UNITED STATES PATENT AND TRADEMARK OFFICE

Application No.	Applicant(s)					
	10/717,979	STRONG, BERNARD					
Office Action Summary	Examiner	Art Unit					
	Patrick F. Brinson	3754					
The MAILING DATE of this communication app Period for Reply A SHORTENED STATUTORY PERIOD FOR REPLY	/ IS SET TO EXPIRE <u>3</u> MONTH(S) OR THIRTY (30) DAYS,					
WHICHEVER IS LONGER, FROM THE MAILING DA - Extensions of time may be available under the provisions of 37 CFR 1.13 after SIX (6) MONTHS from the mailing date of this communication. - If NO period for reply is specified above, the maximum statutory period w - Failure to reply within the set or extended period for reply will, by statute, Any reply received by the Office later than three months after the mailing earned patent term adjustment. See 37 CFR 1.704(b).	rill apply and will expire SIX (6) MONTHS from	the mailing date of this communication. D (35 U.S.C. § 133).					
Status

DETAILED ACTION

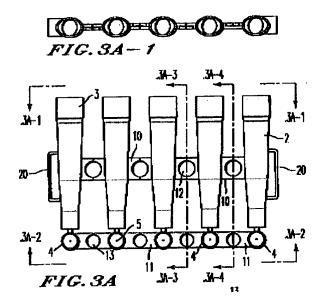
The patent to **Chiesi et al.** discloses in fig. 1, a container (2) having a dispensing end (4) and a filling end (3), wherein fig. 3A-1 (see below) best illustrates the filling end having a hollow fill port comprising a circular end proximal to the body and an elliptical end distal to the body, as recited in claims 1 and 11. Additionally, this figure discloses the distal end defining an opening suitable for use in filling the body with a product and the distal end tapers down to the proximal end. The dispensing end (4) comprises a hollow neck in communication with the cavity at the proximal end of the hollow neck with respect to the body and a tip at a distal end of the hollow neck with respect to the body, with the tip comprising a bulb defining a cavity in communication with the hollow neck. The circular end flares out in a generally lateral direction to crate the elliptical end, as recited in claim 9, and therefore the elliptical end tapers down to the circular end, as recited in claim 9, and therefore

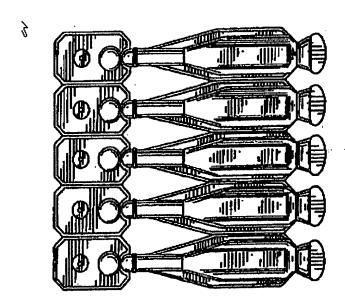
a dose container (10) including a body portion (11) having a tapered section (13) terminating at its upper end in a cylindrical neck portion (14). The lower end of the body portion is initially open to facilitate filling of a product and after filling is adapted to be sealed by application of heat and pressure to provide a welded seam. Fig. 1 discloses the end portion (16) flaring out from the body (12) thereby providing an elliptical shaped end. It would have been obvious to one having ordinary skill in the art at the time the invention was made to modify the end of **Umekawa** so as to facilitate the filling of the container with a liquid material, as suggested by **Federighi**, in the event that the end of **Umekawa** doesn't already function as a hollow fill port in order to insert liquid into the container.
